# Access Compliance Report

## Public Rights-of-Way

### (Curb Ramps)

Intersection ID: 10020730	Main Street: BEATTIES_FORD_RD	Cross Street: N/A	Location: SW
ADA ID: EBACFC9C22C2	Ramp Type: Para	Initial Pass/Fail: Fail	Overall Compliance: No
Severity Score: 12.5			
Codes/Mitigation Info/Possible Solution		Field Measurements/Component Compliance

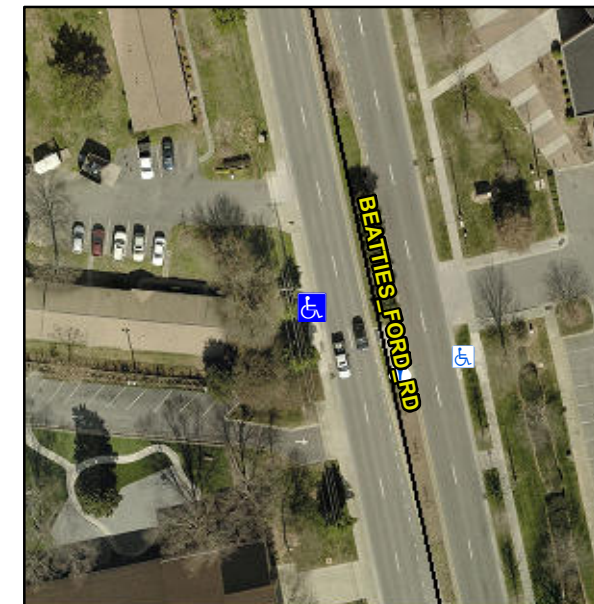
**Remove & Replace Entire Ramp.**

**R304.3.2**

Compliance	Description	Data	Compliance	Description	Data
N/A	Ramp Length LT (in)	73.0	N/A	Ramp Length RT (in)	74.0
Yes	Ramp Width LT (in)	71.0	Yes	Ramp Width RT (in)	71.0
Yes	Ramp Slope LT (%)	8.0	No	Ramp Slope RT (%)	10.1
Yes	Ramp XSlope LT (%)	1.2	Yes	Ramp XSlope RT (%)	1.4
N/A	Landing Length (in)	N/A	N/A	DWS Provided?	N/A
N/A	Landing Width (in)	N/A	N/A	DWS Contrast?	N/A
N/A	Landing Slope (%)	N/A	N/A	DWS Length (in)	N/A
N/A	Landing X Slope (%)	N/A	N/A	DWS Full Width?	N/A
N/A	Landing Curb? (Y/N)	N/A	N/A	DWS Offset (in)	N/A
N/A	Shared Landing?	N/A			
N/A	Gutter Ponding?	N/A	N/A	Gutter Slope (%)	N/A
N/A	Gutter Lip Ht (in)	N/A	N/A	Gutter X Slope (%)	N/A
N/A	Painted X Walk1?	No	N/A	Painted X Walk2?	N/A
	X Walk 1 Direction	To NE		X Walk 2 Direction	N/A
N/A	X Walk 1 Width (in)	N/A	N/A	X Walk 2 Width (in)	N/A
	X Walk 1 Slope (%)	4.3		X Walk 2 Slope (%)	N/A
	X Walk 1 X Slope (%)	1.2		X Walk 2 X Slope (%)	N/A
N/A	Ramp inside XWalk1?	N/A	N/A	Ramp inside XWalk2?	N/A
